03-321 Modifications to crankshaft

Increased displacement engine 603.970

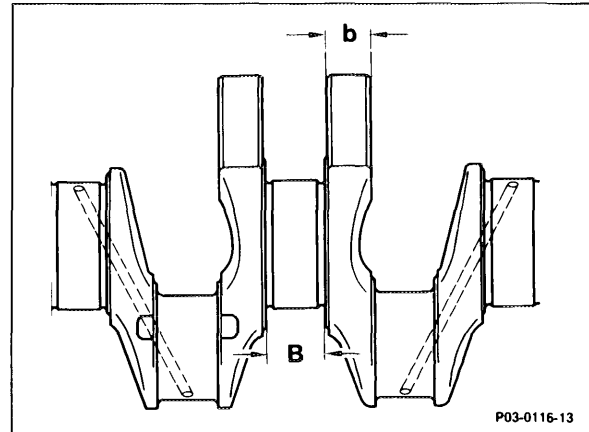
The stroke was increased to 94.2 mm and the web width (b) reduced to 21.75 mm to increase the displacement (3.5 l) on the 603.970 engines.

Engine 602.96 crankshaft webs

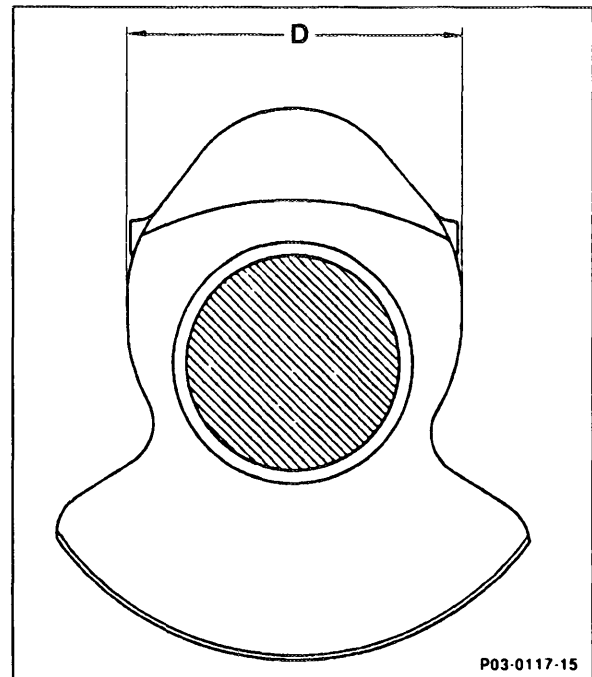
On engine 602.96 starting 12/87 the web width (D) was increased by 8 mm for a total of 90 mm.

D 90 mm (engine 602.961)
